POST-FUKUSHIMA NEAR-TERM TASK FORCE RECOMMENDATION 2.1
Supplemental Guidance for the Evaluation of Dam Failures

Post-Fukushima Near-Term Task Force Recommendation 2.1
 Supplemental Guidance for the Evaluation of Dam Failures
 August 21, 2012, Revision AB

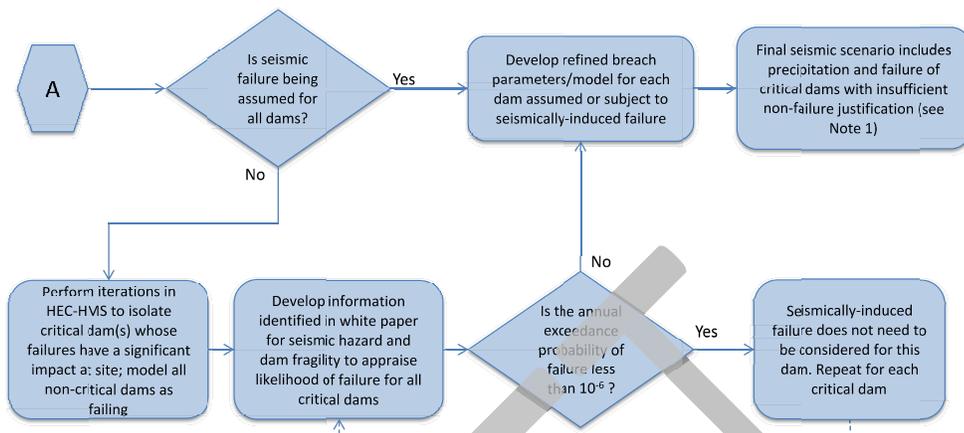
Formatted: Font: Bold
Formatted: List Paragraph, Bulleted + Level: 1 + Aligned at: 0.25" + Indent at: 0.5"
Formatted: Font: 10.5 pt
Formatted: Font: 10.5 pt
Formatted: Font: 10.5 pt
Comment [g11]: Clarify this thought

Comment [g12]: Possibly develop a logic diagram depicting this thought process?

Figure 9 – Distance/Height of Dam Plot

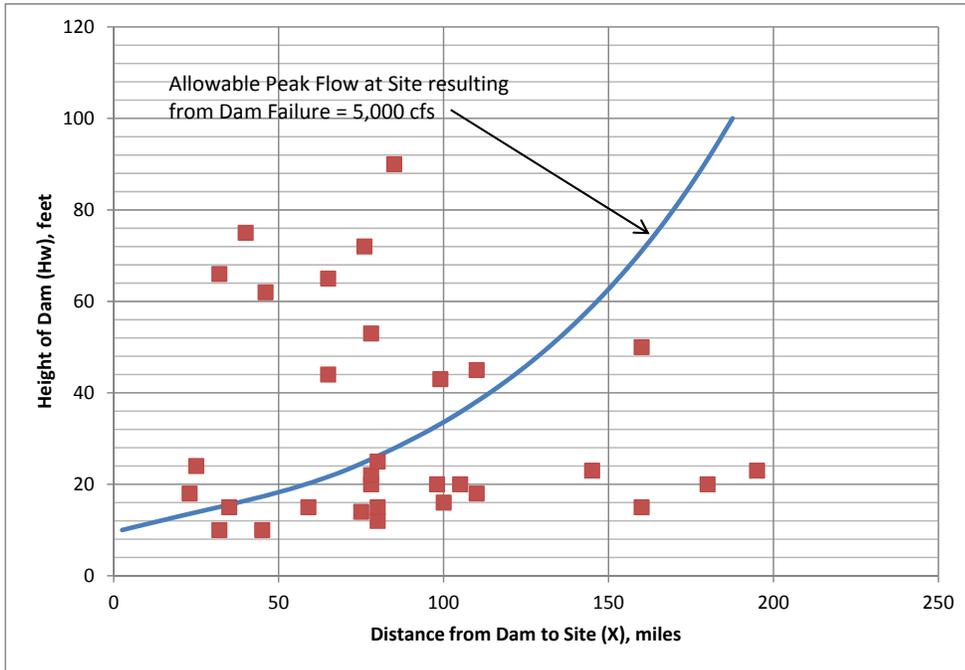
Comment [g17]: Possibly move to an appendix. Describe limits of scope of applicability (downstream distance, dam height, etc...) and reflect limits in figure.

Comment [g20]: Needs further development to address this issue; define limits in example application of USBR equations.

Add example for multiple dams and zones.

Comment [g21]: Possibly move to an appendix.

Describe limits of scope of applicability (downstream distance, dam height, etc...) and reflect limits in figure.
